**Your Reference: SSD 7155**

**Re: SSD 7155, Prestons Industrial Warehouse and Distribution Centre  
Lots 33, 34, 35, 43 in DP 2359 and Lot 20 in DP 1173483**

We refer to the Department of Planning & Environment (**DPE**) Notice of Exhibition in respect of the abovementioned State Significant Development (**SSD 7155**), to which TransGrid responds as follows.

Syd South – Syd West No2 330KV T/L	
	Feeder 12, Structure span 350 – 353	
Property of Transgrid. No warranty is given that information shown is complete or accurate.	PRODUCED FROM TAMIS	Scale: 1:5472
30/03/2016 15:19:43 Created by: P86813	A4

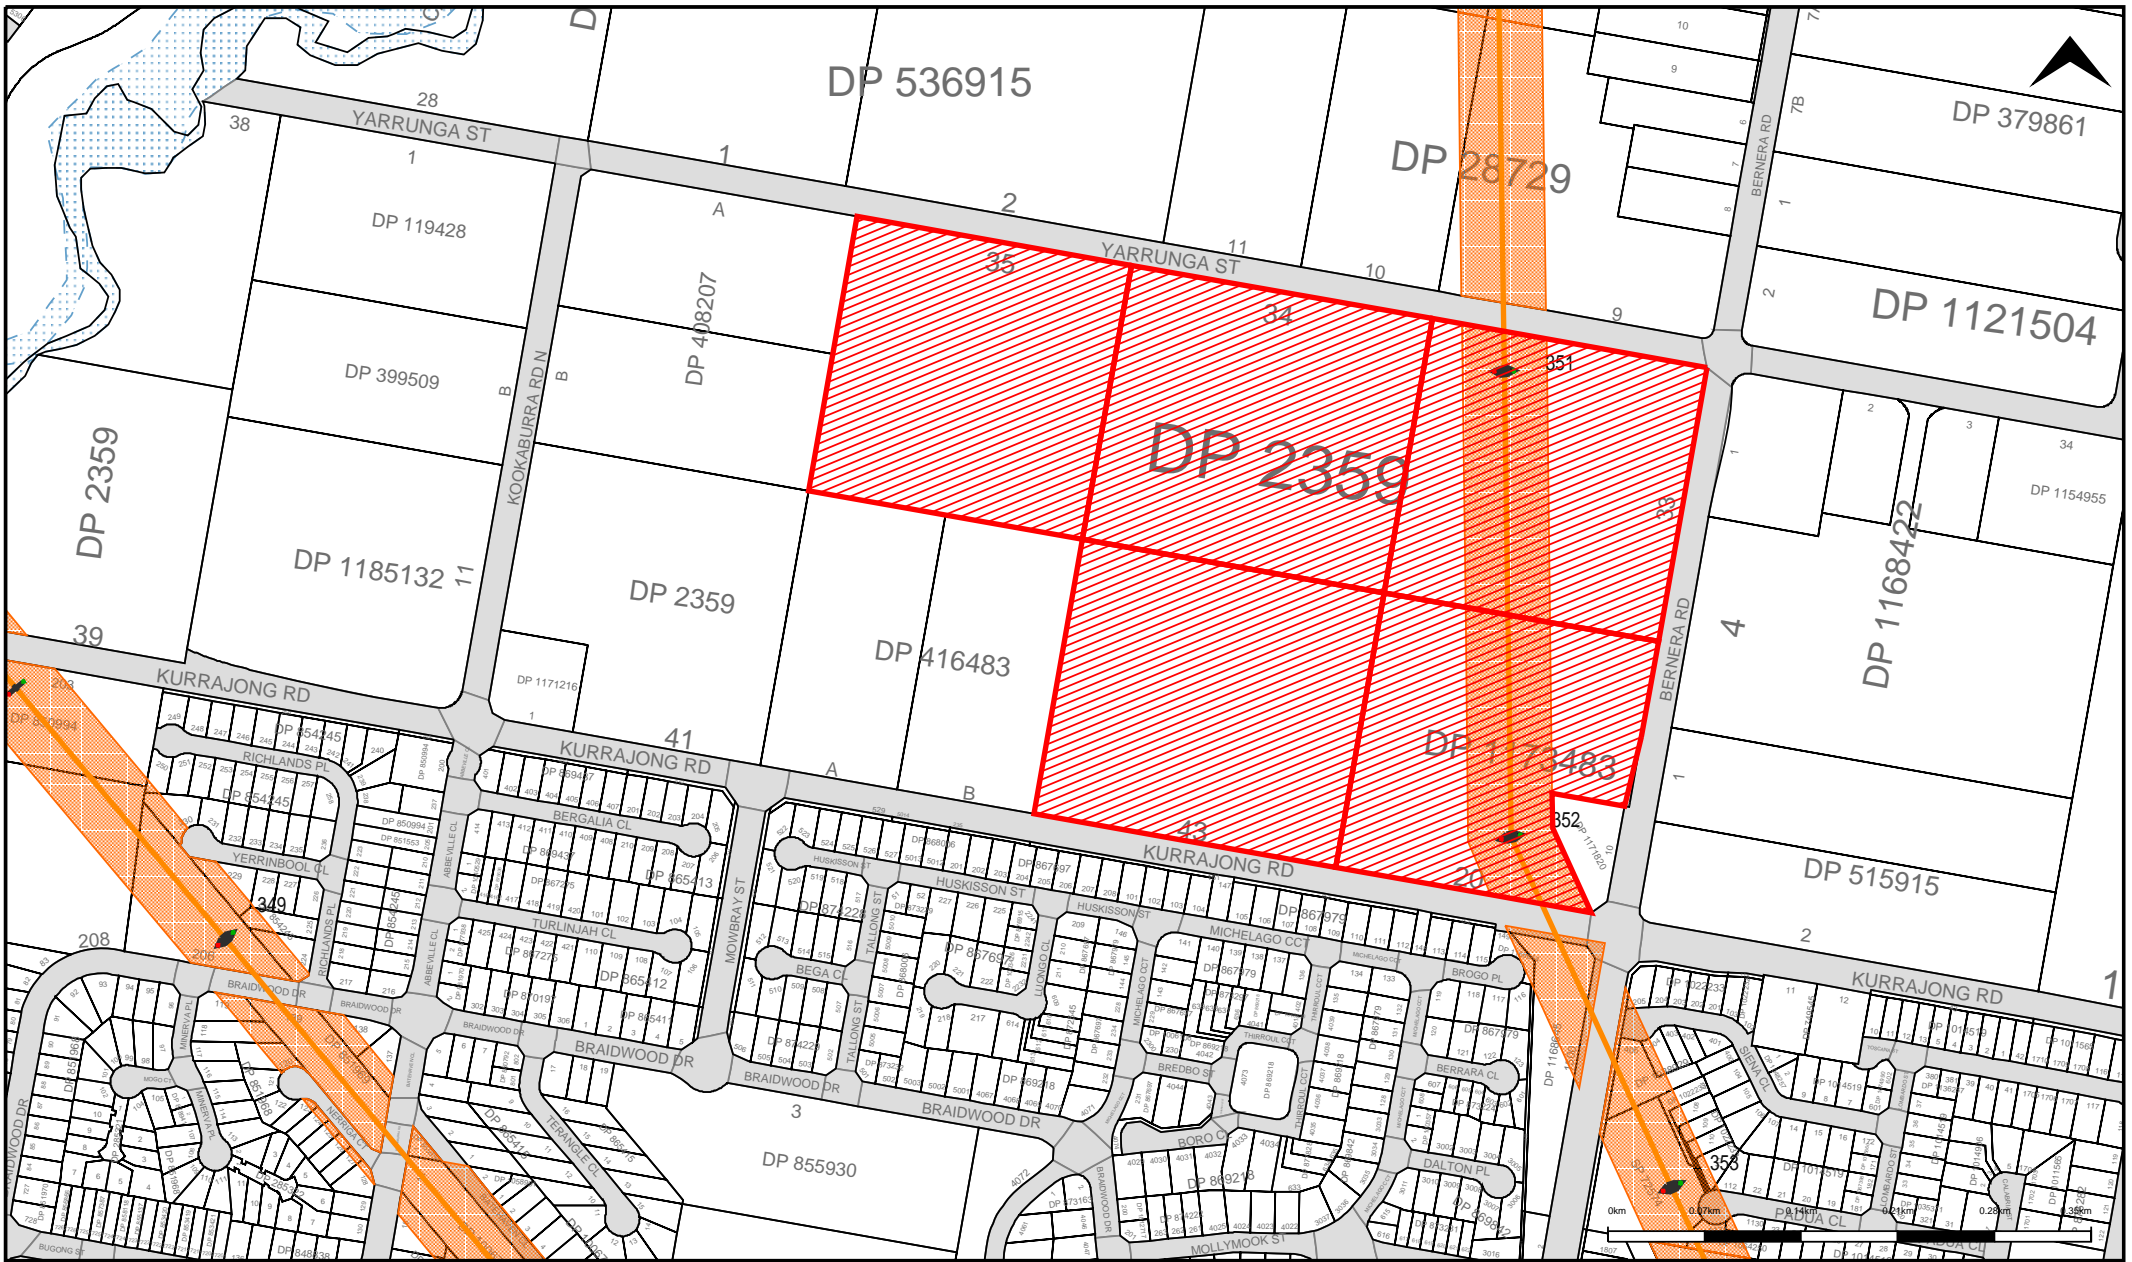
There are two parcels of land forming part of the development site that are subject to TransGrid's easement and high voltage transmission infrastructure, being Lot 20 in DP1173483 and Lot 33 in DP2359. This land is subject to 60.96 metre wide easement. Please find enclosed a TransGrid plan that identifies the approximate position of our easement and infrastructure.

- 1) The horizontal clearance around the transmission towers (stanchion 351 and 352) should be a minimum of 16 metres from the outside edge of the transmission tower legs. This minimum horizontal clearance is required due to the extensive amount of easement encroachment sought by the developer on this site. Despite this, the western horizontal clearance proposed for transmission tower 351 (being 16880mm as shown in *Drawing No. DA-A 102 Issue D*) should remain 'as is'. Further, in accommodating these horizontal clearances, TransGrid may require modifications to the transmission towers as outlined in item 2 of these conditions.

- 2) TransGrid's transmission towers possess subterranean earthing straps that protrude diagonally out by 15 metres from each leg of a structure and are situated approximately 500mm below the ground surface. These earthing straps must not be disturbed and pose a dangerous hazard under transmission line fault conditions. In the event of any damage to the earthing straps, please pause all works immediately and contact TransGrid.

- 3) Lockable removable bollards are to be installed around the perimeter of the 16 metre horizontal clearance setback for each transmission tower to prevent prohibitive vehicle encroachment. Each bollard is to be earthed by a duly qualified electrician. The design plans should be amended to reflect this requirement
- 4) TransGrid's access to the transmission lines, stanchions and easement must be maintained at all times, including during the construction period. Please note TransGrid operates 40-ton heavy vehicle maintenance trucks throughout the full length of the easement. Please ensure the ground makeup and finished slab is capable of bearing the weight of our mobile plant and equipment, as TransGrid will not be responsible for damage to finished surfaces arising from our use of our Transmission easement.
